CITY OF MADISON

PLAN OF PROPOSED IMPROVEMENT

601 RAYOVAC DRIVE REDEVELOPMENT

CITY PROJECT NO. 11740

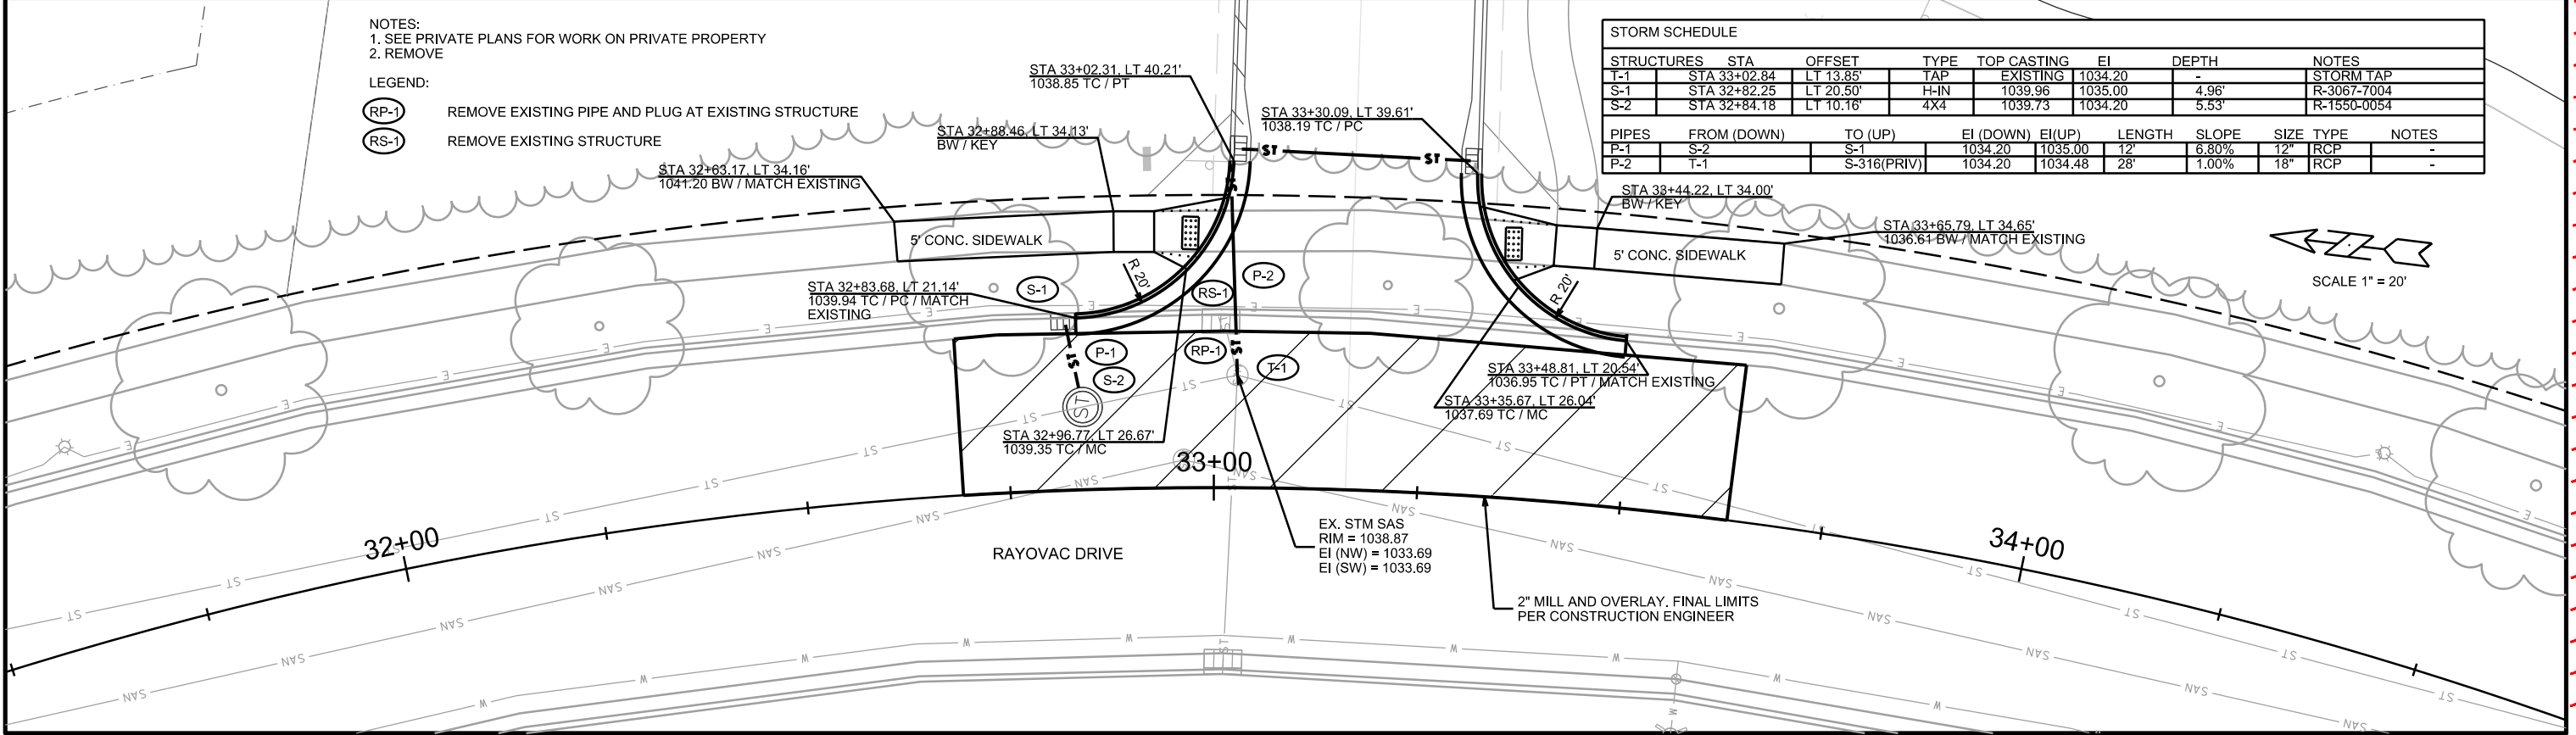
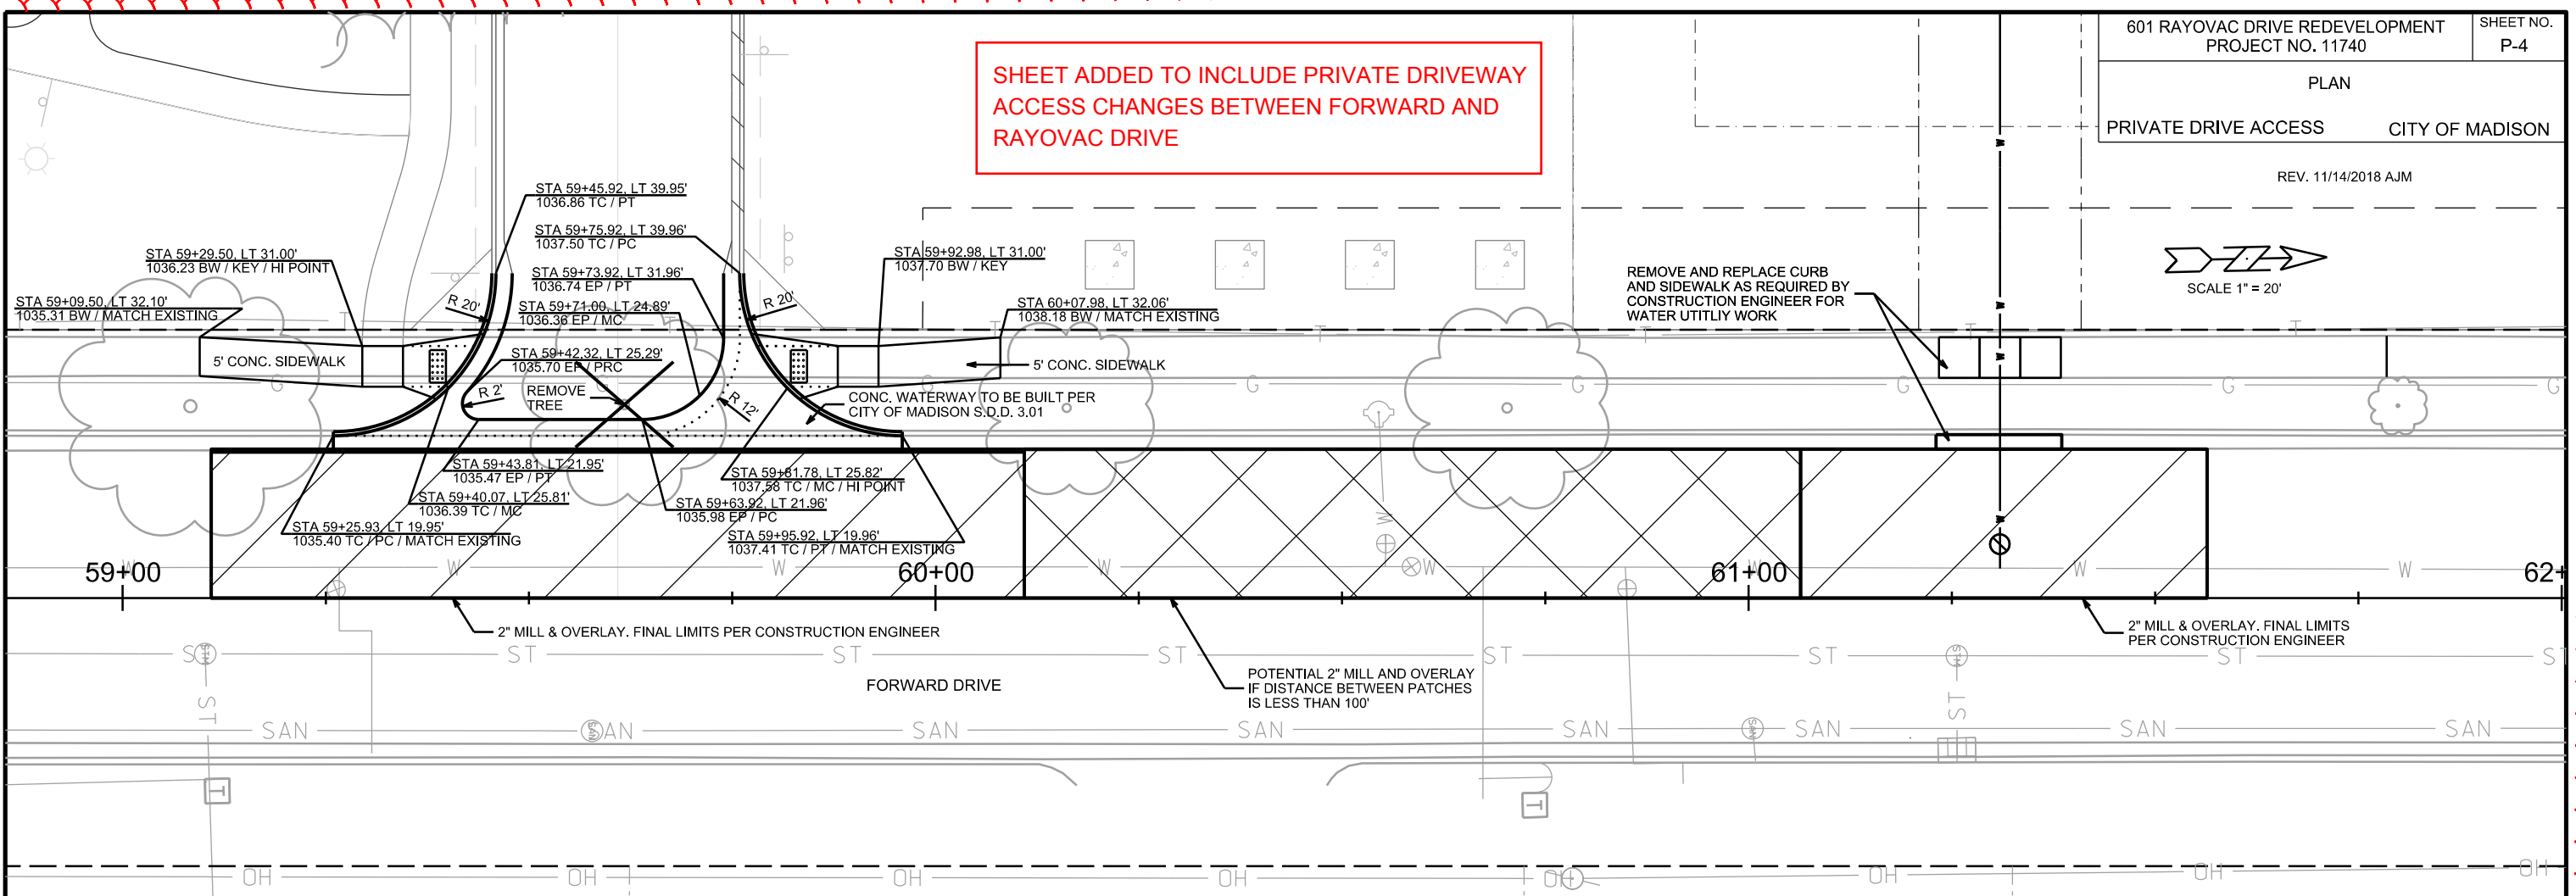
**SHEET ADDED TO INCLUDE PRIVATE DRIVEWAY
ACCESS CHANGES BETWEEN FORWARD AND
RAYOVAC DRIVE**

WATER PLAN AND PROFILE

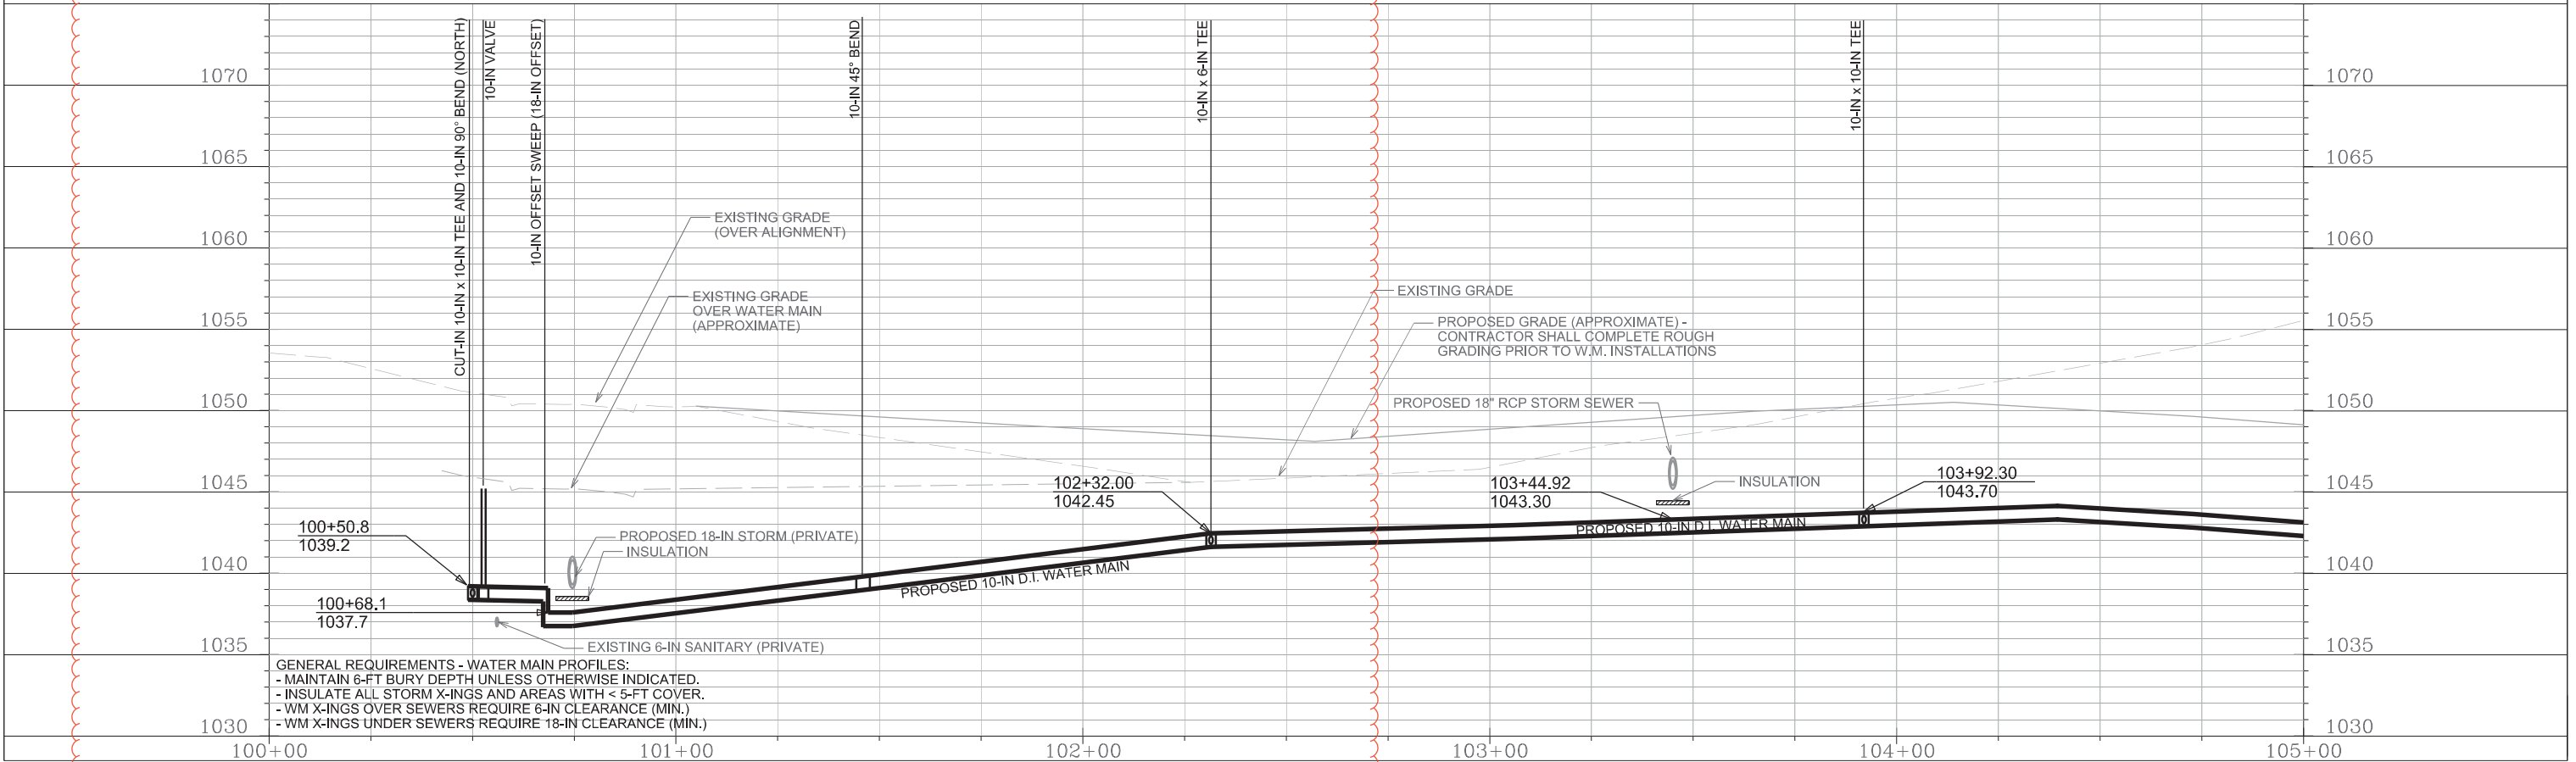
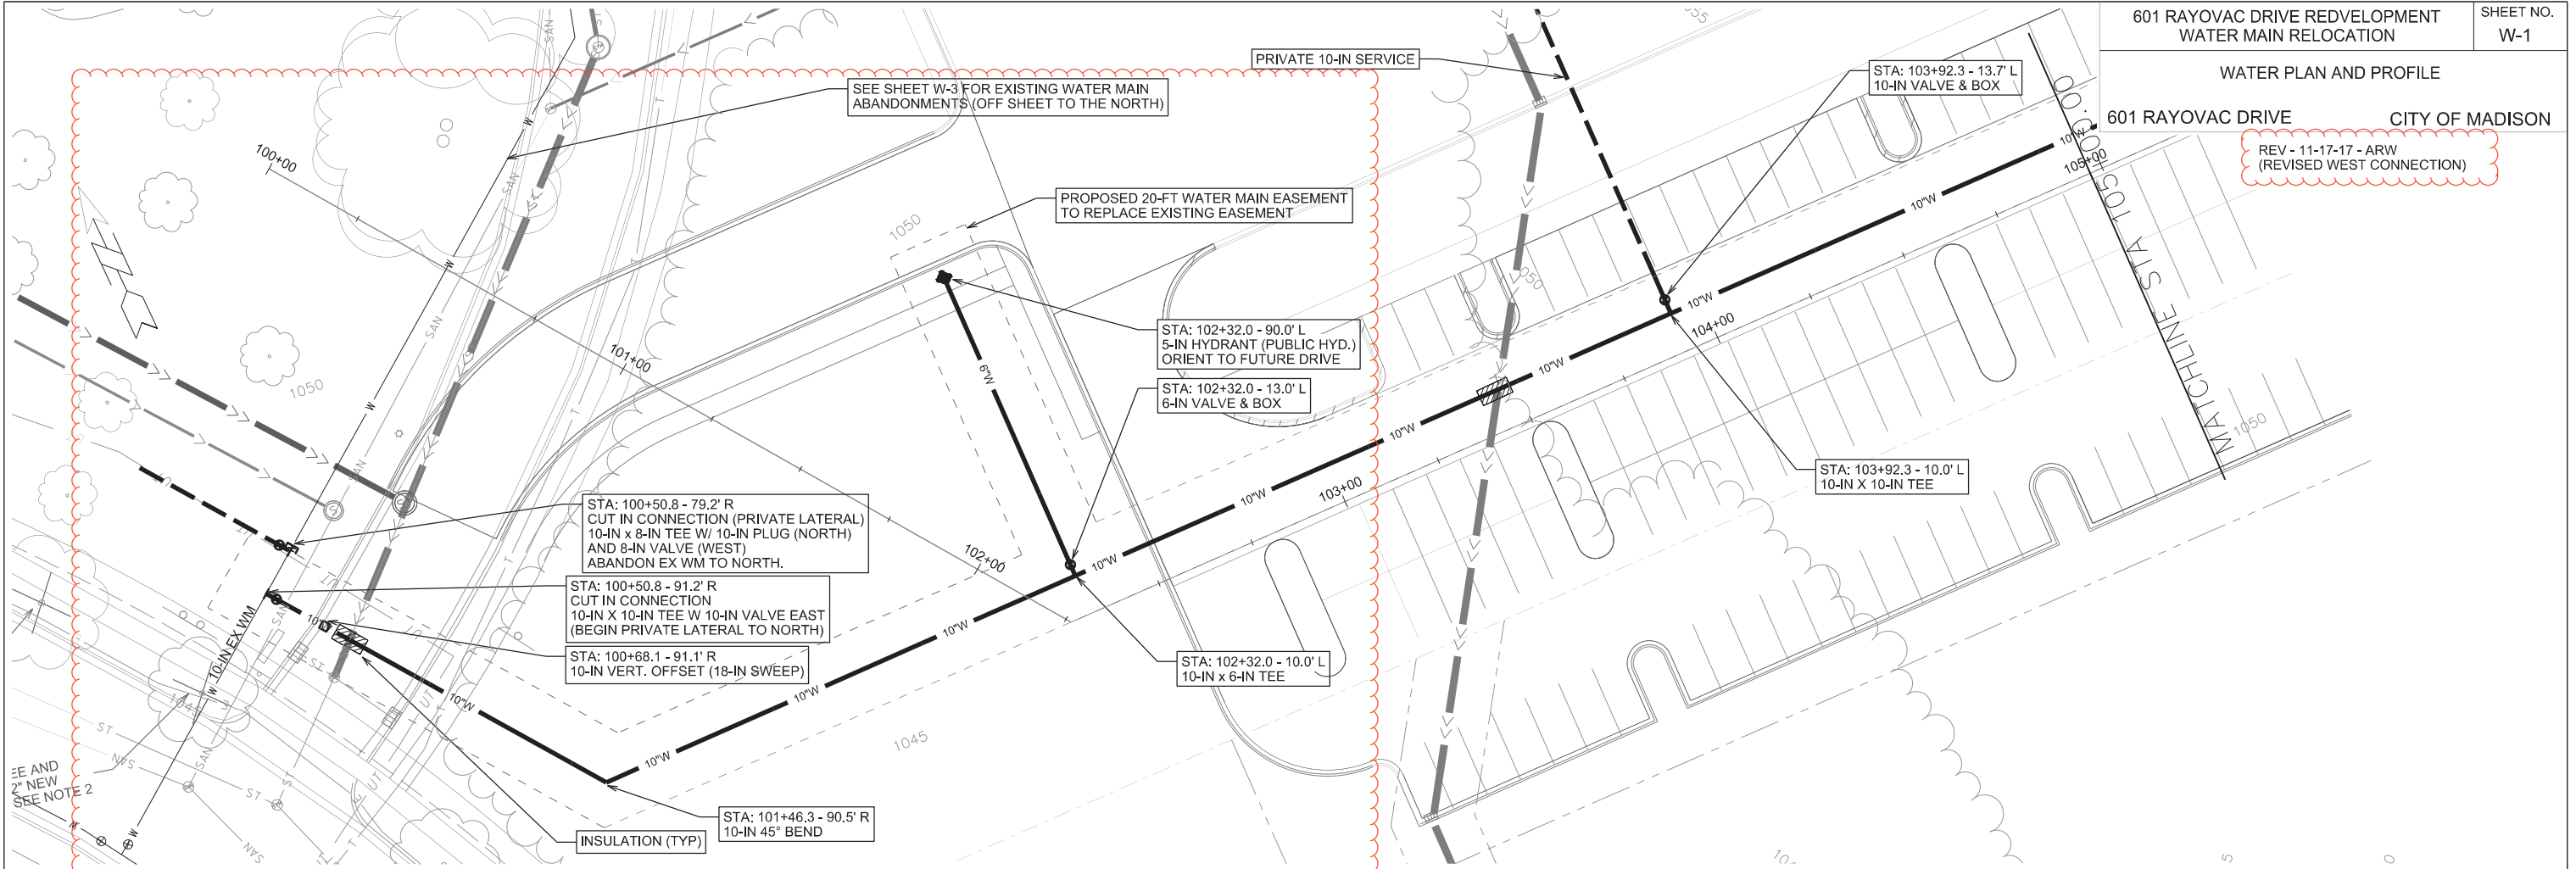
REV - 11-17-17 - ARW
(REVISED WEST CONNECTION)

CROSS SECTIONS

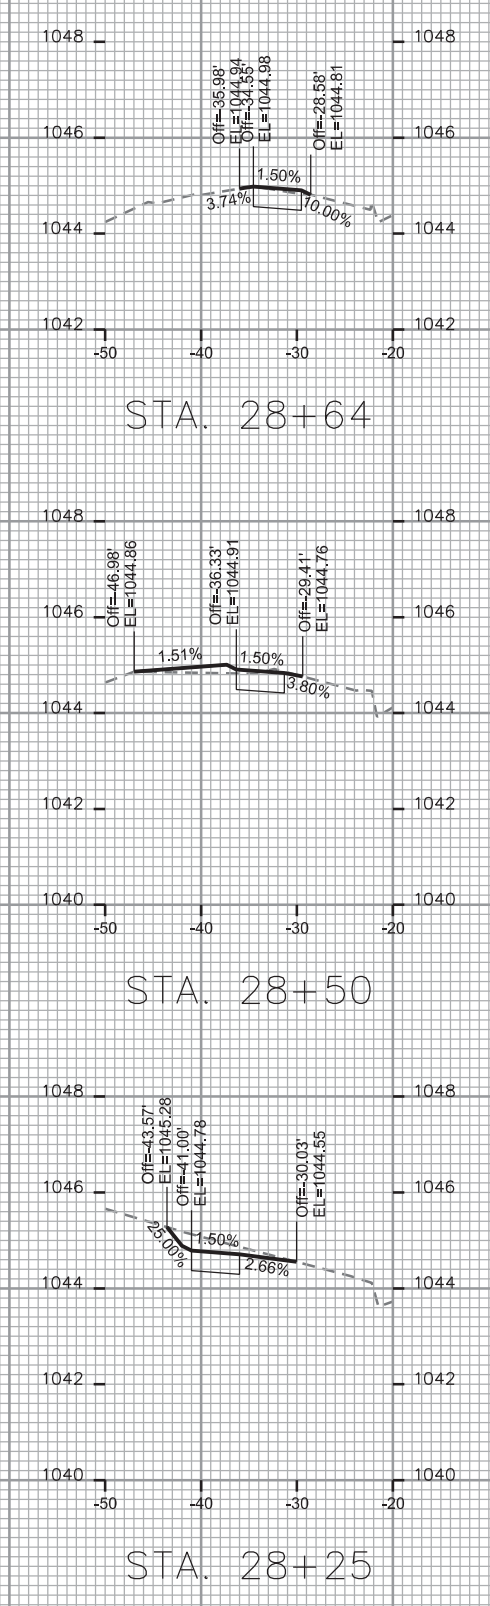
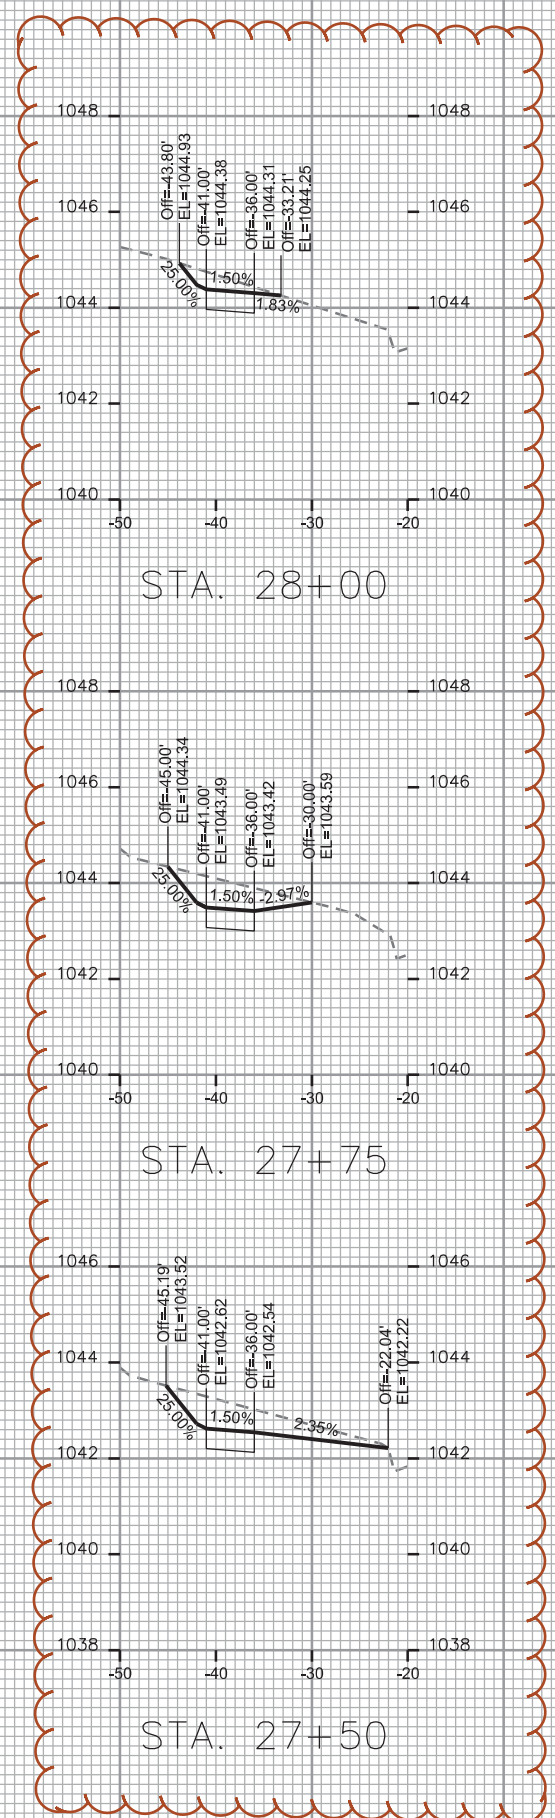
REV. 2018 08-17 JPS
ADJUSTED SIDEWALK GRADES
TO REDUCE TERRACE SLOPE
FOR BUS PAD
